Request for Class II Permissive Change(C2PC)

FCC ID: VG8EM925AYYGE

This is a C2PC application for which the previous grant was issued on 2018-05-05.

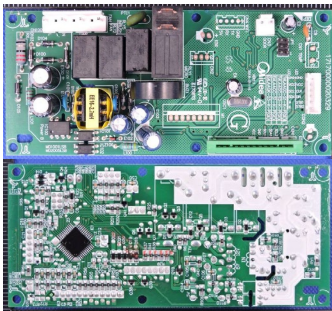
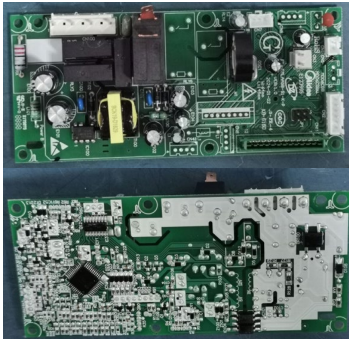
No.:	Original	New	Difference(s)
1			Keypad: Updated front keypad to accommodate child lock function (Child resistant oven door function).
2			Mother board: Modified the peripheral circuit (non-RF circuit) and some individual components and PCB layout. The magnetron and other circuit are exactly same as before.
3	Not Applicable		The new one adds a solenoid valve locking mechanism, the original is not.
